Subject: Duke Energy Carolinas, LLC  
Oconee Nuclear Station, Units 1, 2, and 3  
Docket Nos. 50-269, -270, and -287  
Emergency Plan Revision 2019-004

Oconee Nuclear Station Emergency Plan 10 CFR 50.54(q) Summary of Changes Attachment 1

**Change Matrix**  
**ONS Emergency Plan Section B, P, App 5**      Page 1 of 4  
**Rev 2019-004**

4.	old p.B-25 Table B-1b	<b>Current</b>		combined OAC and IT responsibilities

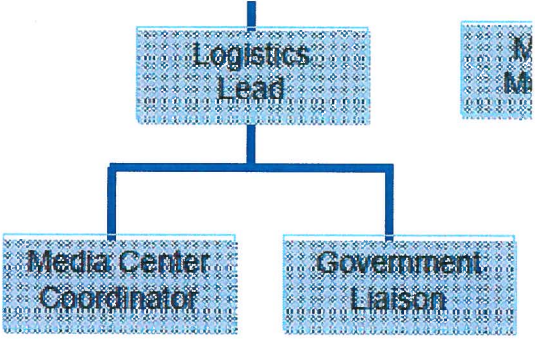
Attachment to 50.54q																																																						
CHANGE MATRIX																																																						
#	Page /Section	Current		Proposed Change		Reason																																																
		<table><tr><th rowspan="2">Functional Area</th><th rowspan="2">Major Tasks</th><th rowspan="2">Standard ERO Emergency Positions</th><th colspan="3">Minimum Staffing</th><th rowspan="2">Full Staff</th></tr><tr><th>45 Min</th><th>75 Min</th><th>Min</th></tr><tr><td rowspan="7">Resource Allocation and Admin</td><td rowspan="3">Administration</td><td>Log Keeper (TSC)</td><td></td><td></td><td></td><td>1</td></tr><tr><td>Log Keeper (OSC)</td><td></td><td></td><td></td><td>1</td></tr><tr><td>Log Keeper (EOF)</td><td></td><td></td><td></td><td>1</td></tr><tr><td rowspan="4">Facility Operations</td><td>Services Manager (EOF)</td><td></td><td></td><td></td><td>1</td></tr><tr><td>OAC Support (TSC)</td><td></td><td></td><td></td><td>1</td></tr><tr><td>IT Support (TSC)</td><td></td><td></td><td></td><td>1</td></tr><tr><td></td><td></td><td></td><td></td><td>1</td></tr></table>	Functional Area	Major Tasks	Standard ERO Emergency Positions	Minimum Staffing			Full Staff	45 Min	75 Min	Min	Resource Allocation and Admin	Administration	Log Keeper (TSC)				1	Log Keeper (OSC)				1	Log Keeper (EOF)				1	Facility Operations	Services Manager (EOF)				1	OAC Support (TSC)				1	IT Support (TSC)				1					1				for more efficient use of personnel

Functional Area	Major Tasks	Standard ERO Emergency Positions				Minimum Staffing				Full Staff																																												
			45 Min	75 Min	Min																																																	
Resource Allocation and Admin	Administration	Log Keeper (TSC)				1																																																
		Log Keeper (OSC)				1																																																
		Log Keeper (EOF)				1																																																
	Facility Operations	Services Manager (EOF)				1																																																
		OAC Support (TSC)				1																																																
		IT Support (TSC)				1																																																
						1																																																
new p.B-24 Table B-1b	<b>Proposed</b>	<table><tr><th rowspan="2">Functional Area</th><th rowspan="2">Major Tasks</th><th rowspan="2">Standard ERO Emergency Positions</th><th colspan="3">Minimum Staffing</th><th rowspan="2">Full Staff</th></tr><tr><th>45 Min</th><th>75 Min</th><th>Min</th></tr><tr><td rowspan="7">Resource Allocation and Admin</td><td rowspan="3">Administration</td><td>Log Keeper (TSC)</td><td></td><td></td><td></td><td>1</td></tr><tr><td>Log Keeper (OSC)</td><td></td><td></td><td></td><td>1</td></tr><tr><td>Log Keeper (EOF)</td><td></td><td></td><td></td><td>1</td></tr><tr><td rowspan="4">Facility Operations</td><td>Services Manager (EOF)</td><td></td><td></td><td></td><td>1</td></tr><tr><td>IT Support (TSC)</td><td></td><td></td><td></td><td>1</td></tr><tr><td>Data Coordinator (EOF)</td><td></td><td></td><td></td><td>1</td></tr><tr><td></td><td></td><td></td><td></td><td>1</td></tr></table>	Functional Area	Major Tasks	Standard ERO Emergency Positions	Minimum Staffing			Full Staff	45 Min	75 Min	Min	Resource Allocation and Admin	Administration	Log Keeper (TSC)				1	Log Keeper (OSC)				1	Log Keeper (EOF)				1	Facility Operations	Services Manager (EOF)				1	IT Support (TSC)				1	Data Coordinator (EOF)				1					1				combined OAC and IT responsibilities for more efficient use of personnel

Functional Area	Major Tasks	Standard ERO Emergency Positions				Minimum Staffing				Full Staff																																												
			45 Min	75 Min	Min																																																	
Resource Allocation and Admin	Administration	Log Keeper (TSC)				1																																																
		Log Keeper (OSC)				1																																																
		Log Keeper (EOF)				1																																																
	Facility Operations	Services Manager (EOF)				1																																																
		IT Support (TSC)				1																																																
		Data Coordinator (EOF)				1																																																
						1
